Share Your Thoughts on the Lubber Run Pedestrian Bridge Location Concept

Image 1: Suggested bridge location.

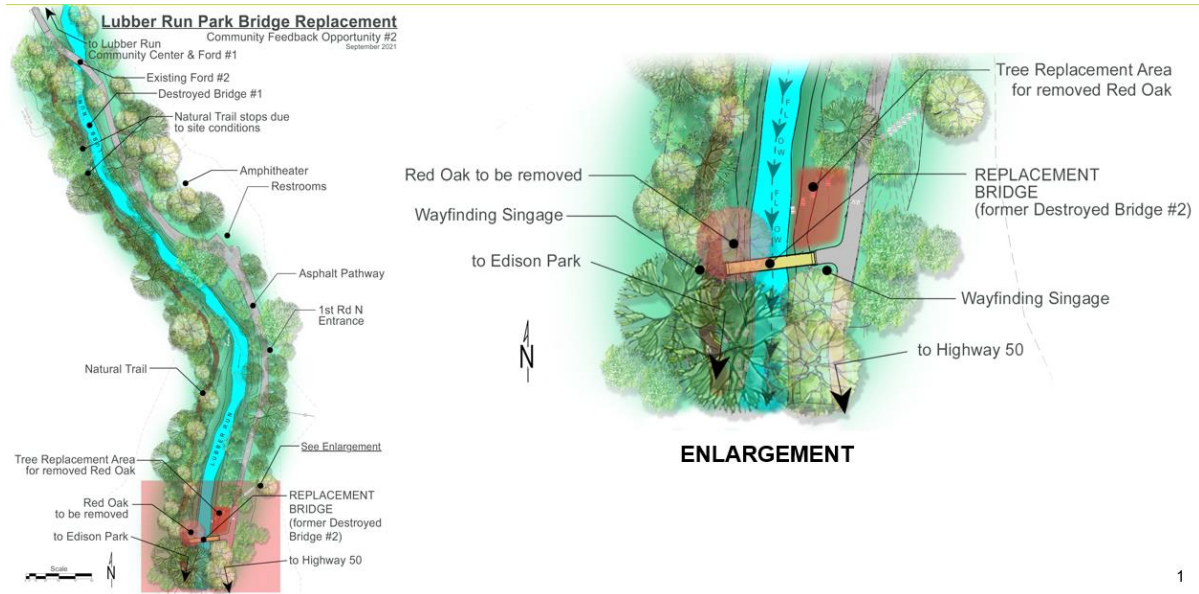
I think this proposed site is great - very close to the previous bridge and well-situated for crossing from the Edison Park, Greenbriar and Bluemont areas over to the Amphitheater, school or shopping center areas. I have been observing that one red oak that is proposed for removal for the past few years as each big flood event further erodes its roots. It is clear that it is going to fall before long on its own after another major flood event there, so taking it down safely is the smart thing to do. (Even though of course it is sad to lose another old giant.)

This is the best location for the First bridge, but seek additional capital improvements soonest to replace the Second bridge, OR, more importantly, alter the 'fords' by making them concrete arches that allow water to flow unheeded. Currently, they flood, and allow water to fester, and impede passage during any water weather event. Having an arch would allow a lower-cost fix.

I agree with the location BUT nothing is said about the design of the new bridge's design to withstand another flooding event which is sure to happen again. Please inform the community on this point.

Thanks for sharing the updated project status for the replacement bridge. I support the location and the "maintenance" removal of the imperiled red oak. This location seems to suit many needs - a crossing closer to Rte. 50, minimal environmental impact and improved access to the Edison St. park.

Could this be a raised or arched design, to place the bridge above a future higher flood stage, and still meet ADA requirements?

What is to stop the new bridge from being washed out as well? Are there design improvements to mitigate the risk? What about elevating the bridge?

This location will provide a needed link between the east and west sides of Arlington Forest on the south side of the park. A concern is what will be done at that location or with the bridge design to prevent another bridge wash out during a flooding event? The further south the bridge, the higher the stream becomes during flooding, I believe because of water backing up at the Route 50 underpass.

two bridges have been wiped out by floods(2006, 2019) at this location. the constriction of LR at this point will be a bottleneck in any future situation of flood-stage flow of LR. you better build the new bridge really high and wide, if you don't eliminate the constriction in LR. better to build a nice ford there, rather than a bridge. build stepping stones into the ford and it will be usable 99.99% of the time. when flow is so great that stepping stones don't work, it is too dangerous to cross LR.

The proposed bridge does not look high enough to avoid destruction during flood.

What really needs to be done is to shore up Lubber Run's banks and paths, which are quickly and severely eroding because of these frequent high-volume storms and their amplification due to the storm-water system. That erosion undercuts trees (you can see the RED OAK, identified by the arrow, on the BEFORE photo). When they fall (along with some farther from the banks), large branches are swept into the bridges, pile up there, and destroy them. Putting another bridge is a sad waste of county funds. The stream needs so much work and perhaps something could be done to diminish the volume delivered by the storm water system.
